**MONTGOMERY COUNTY HISTORIC PRESERVATION COMMISSION**  
**STAFF REPORT**

<b>Address:</b>	7 W. Kirke, Chevy Chase	<b>Meeting Date:</b>	9/6/2023
<b>Resource:</b>	Contributing Resource <b>Chevy Chase Village Historic District</b>	<b>Report Date:</b>	8/30/2023
<b>Applicant:</b>	Marc & Lena Katz Setphanie Fisher, Agent	<b>Public Notice:</b>	8/23/2023
<b>Review:</b>	HAWP	<b>Tax Credit:</b>	N/A
<b>Permit Number:</b>	103938 & 1040852	<b>Staff:</b>	Dan Bruechert
<b>Proposal:</b>	Hardscape Alteration, EV Charger Installation, Water Feature Installation

**HARDSCAPE DETAILS - WATER FEATURE**

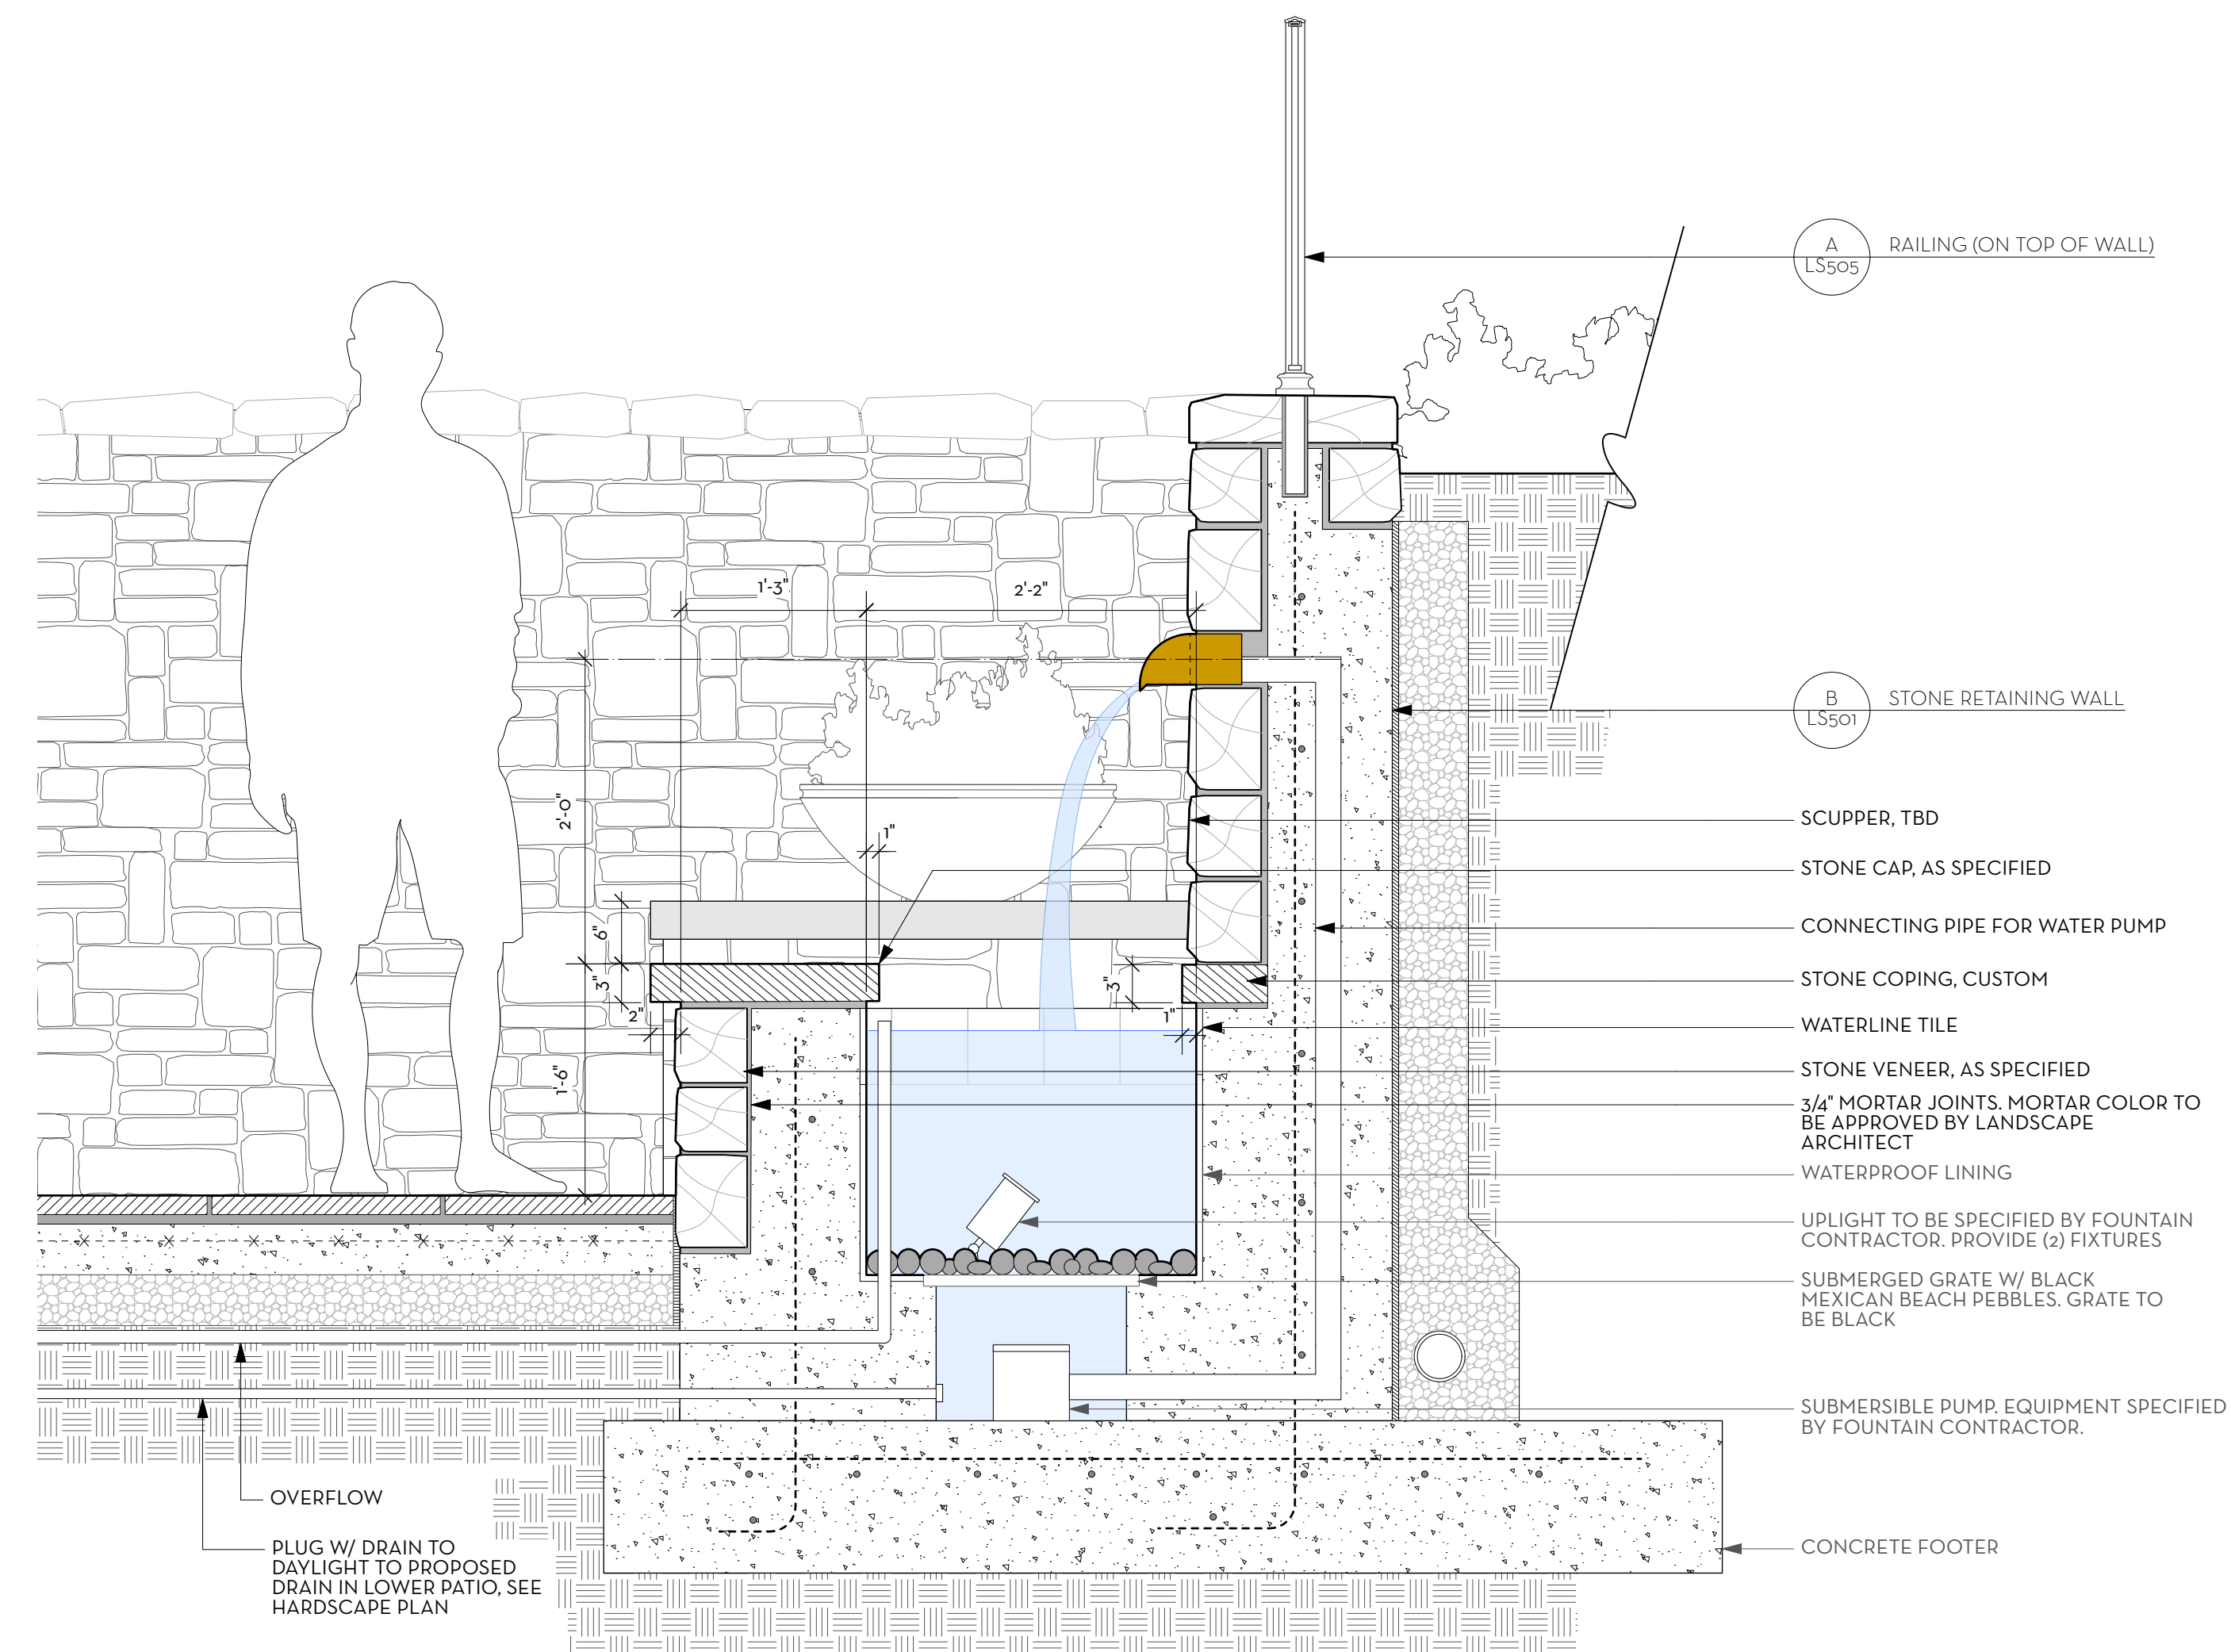
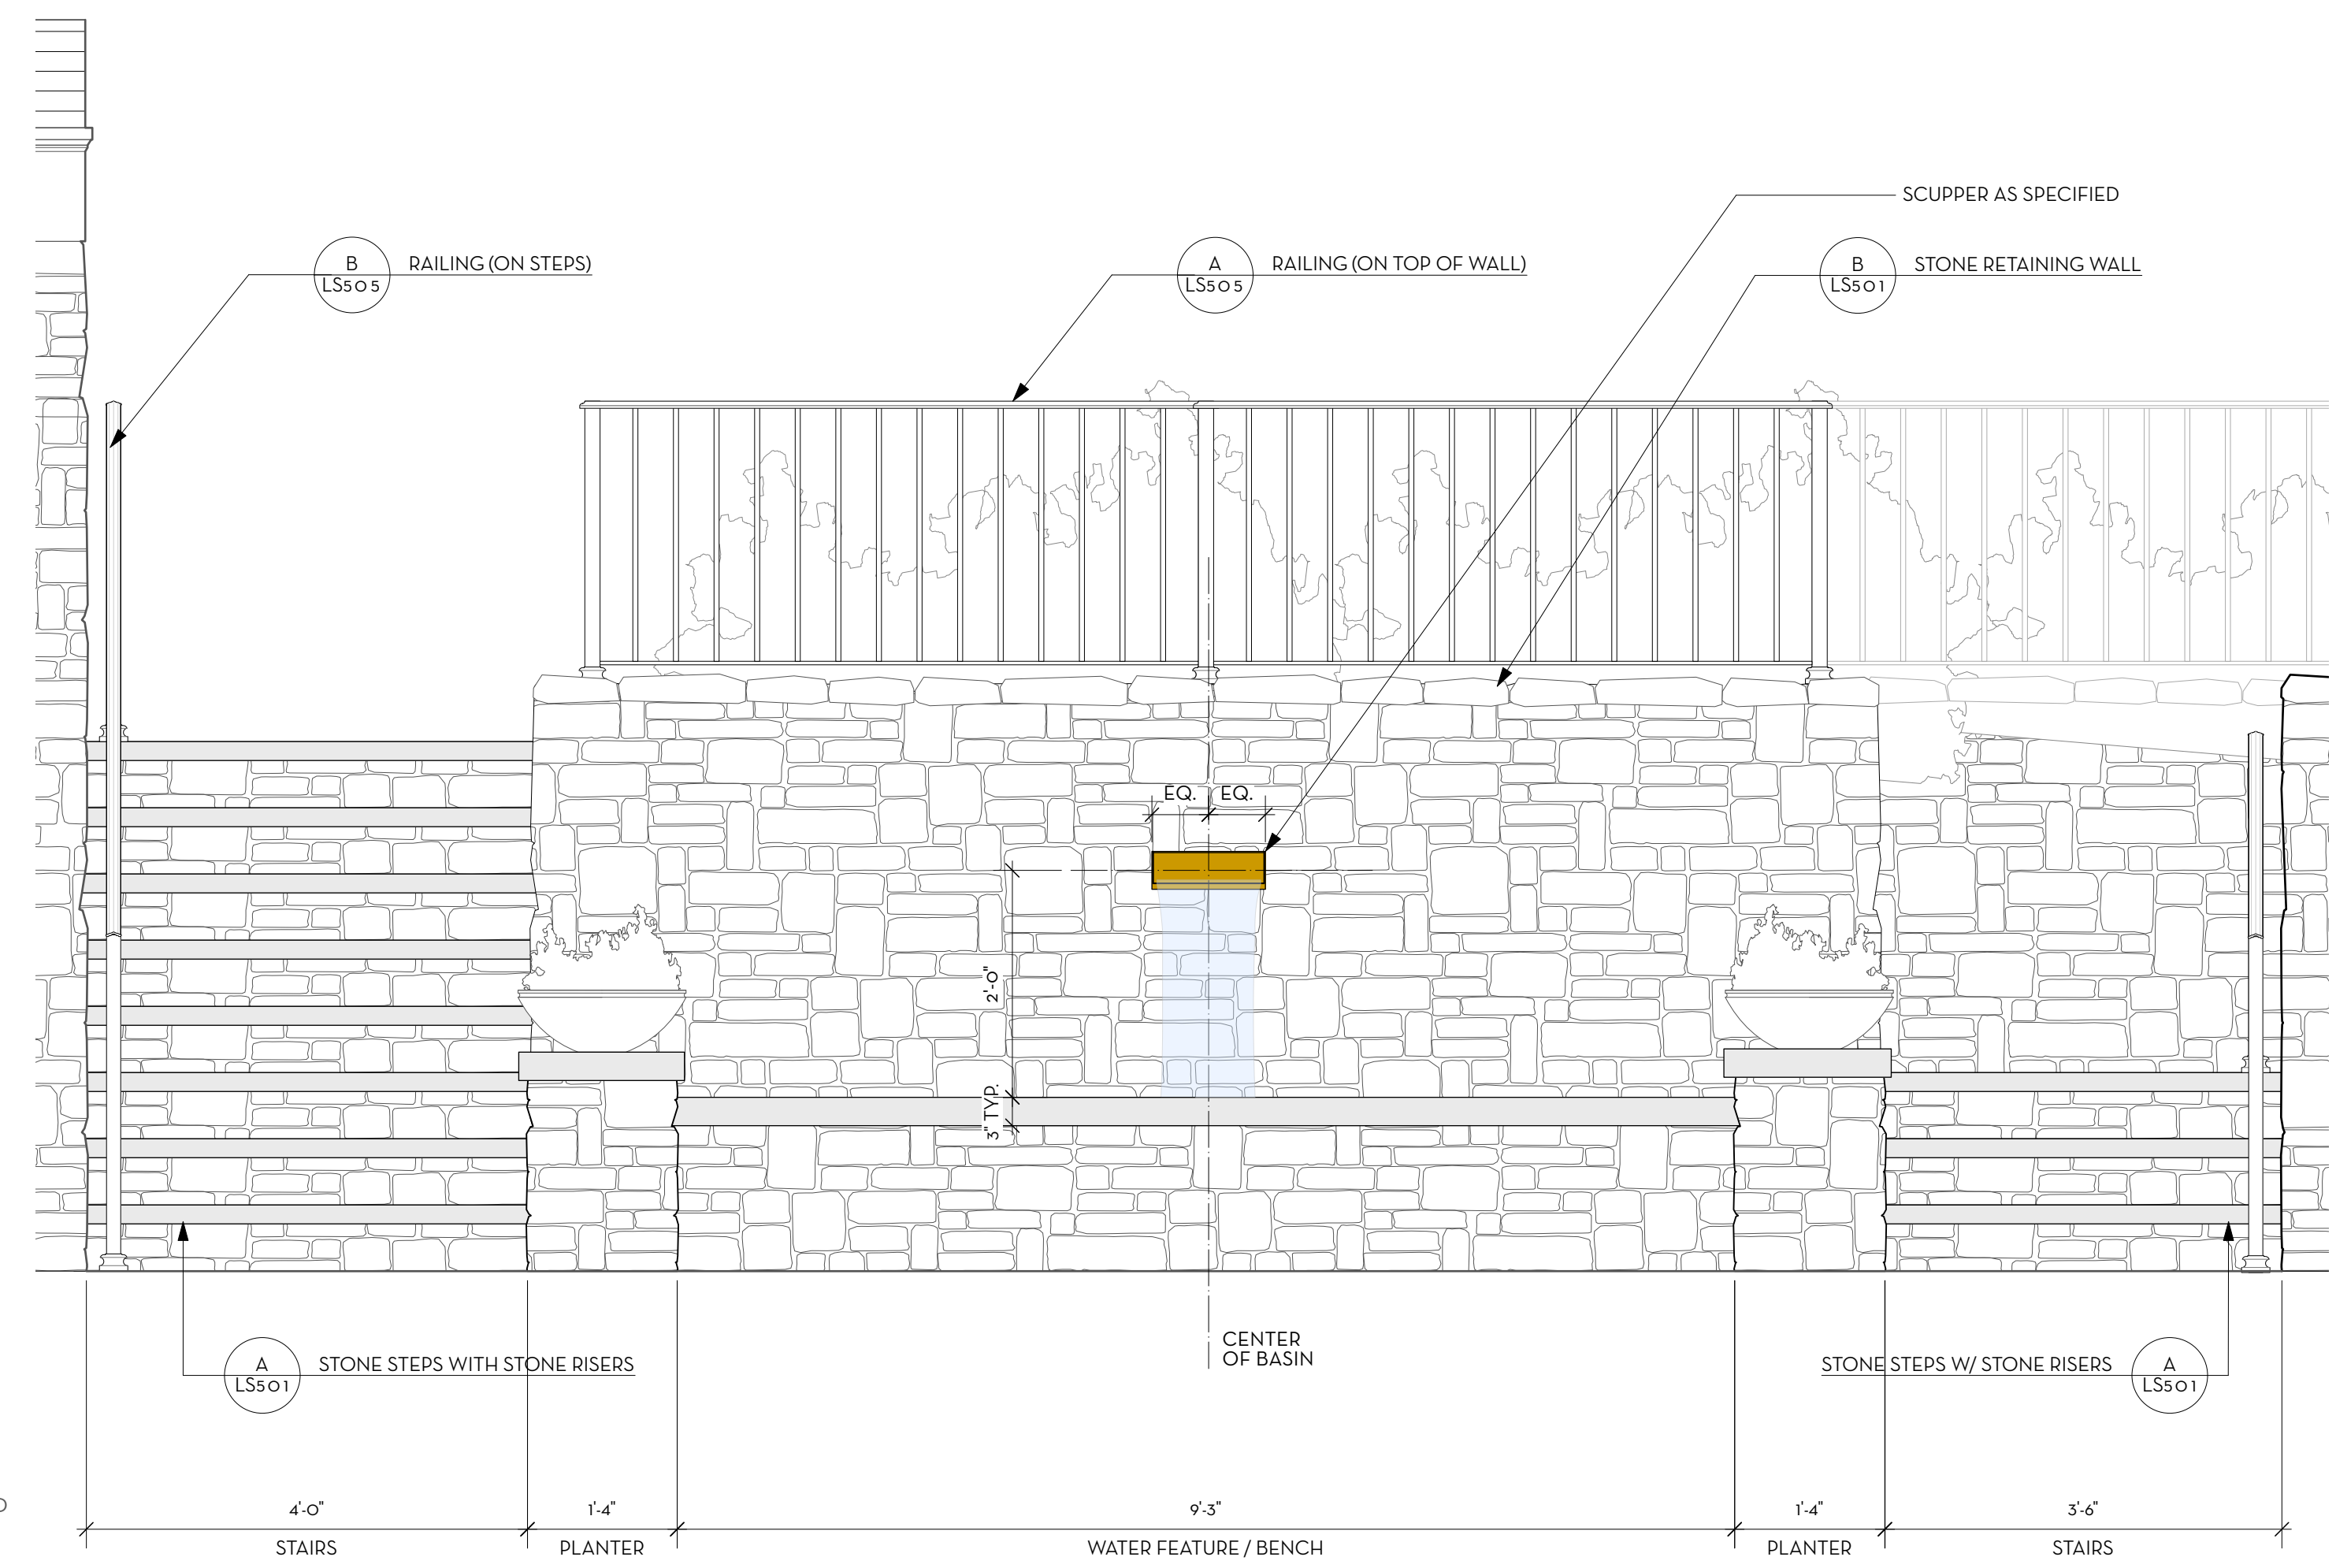
Surrounded by the new stairs, between the house and the pool, the applicant proposes to install a water feature with a fountain. The fountain will be constructed using the same stone as the stairs and will not be visible from the public right-of-way. As a feature not visible from the right-of-way, this work should be approved as a matter of course.
